Addendum 2 - Questions

① TYPICAL WORKSTATION
12' = 1'-0"

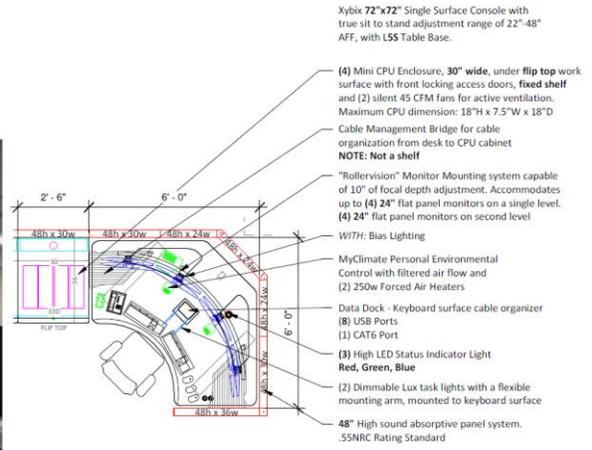
- 34) **Will the coax be sharing the same faceplate as data, or they in a box location at a higher AFF location?** *They will share the same location and be installed into Evolution series 4-gang wall box model # EFSB4 (<https://cdn-docs.av-iq.com/other//EFSB%5FCUtSheet%2Epdf>)*
- 35) **Ap locations** – specs on what is need at each location, surface box, flush faceplate, service loops? *Cabling terminated in an above the ceiling grid single service mount box at each location is required. Physically mounting the APs is not.*
- 36) **Dispatch room A147-** Are these floor boxes? *Room A147 has an 8” raised floor. Wiring access to this room will be available through the floor from the datacenter. These runs will be terminated in Xybix Workstations.*
